# Access Compliance Report

### (Curb Ramps)

Intersection ID: N/A	Main Street: INVERNESS_BAY_RD	Cross Street: PERTH_MOOR_RD	Location: NE
ADA ID: 423AFBFDC940	Ramp Type: Perp	Initial Pass/Fail: Fail	Overall Compliance: No
Severity Score: 37.5			
Codes/Mitigation Info/Possible Solution		Field Measurements/Component Compliance

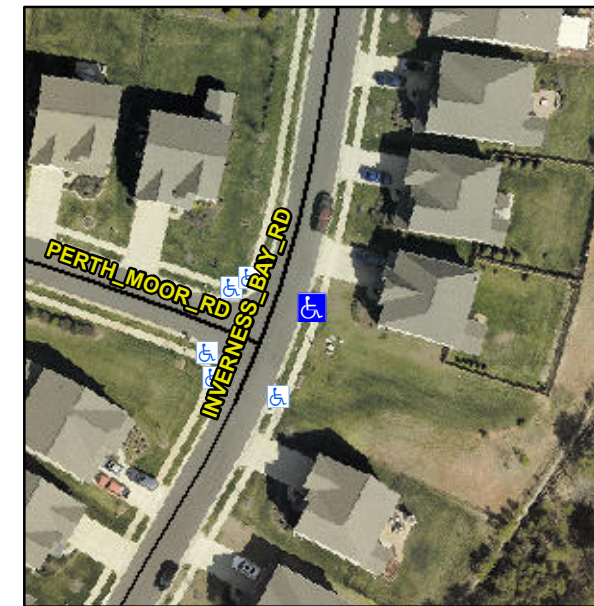
**Not Found, R304.2.2, R304.5.3**

Compliance	Description	Data	Compliance	Description	Data
N/A	Ramp Length (in)	48.0	No	Ramp Slope (%)	10.7
Yes	Ramp Width (in)	48.0	No	Ramp XSlope (%)	7.1
N/A	Flare Type LT	N/A	N/A	Flare Type RT	N/A
N/A	Flare Slope LT (%)	N/A	N/A	Flare Slope RT (%)	N/A
N/A	Flare Traversable LT?	N/A	N/A	Flare Traversable RT?	N/A
N/A	Landing Length (in)	N/A	N/A	DWS Provided?	N/A
N/A	Landing Width (in)	N/A	N/A	DWS Contrast?	N/A
N/A	Landing Slope (%)	N/A	N/A	DWS Length (in)	N/A
N/A	Landing X Slope (%)	N/A	N/A	DWS Full Width?	N/A
N/A	Landing Curb? (Y/N)	N/A	N/A	DWS Offset (in)	N/A
N/A	Shared Landing?	N/A			
N/A	Gutter Ponding?	N/A	N/A	Gutter Slope (%)	N/A
N/A	Gutter Lip Ht (in)	2.0	N/A	Gutter X Slope (%)	N/A
N/A	Painted X Walk1?	No	N/A	Painted X Walk2?	N/A
	X Walk 1 Direction	To NW		X Walk 2 Direction	N/A
N/A	X Walk 1 Width (in)	N/A	N/A	X Walk 2 Width (in)	N/A
	X Walk 1 Slope (%)	2.1		X Walk 2 Slope (%)	N/A
	X Walk 1 X Slope (%)	5.0		X Walk 2 X Slope (%)	N/A

**Remove & Replace Entire Ramp.**
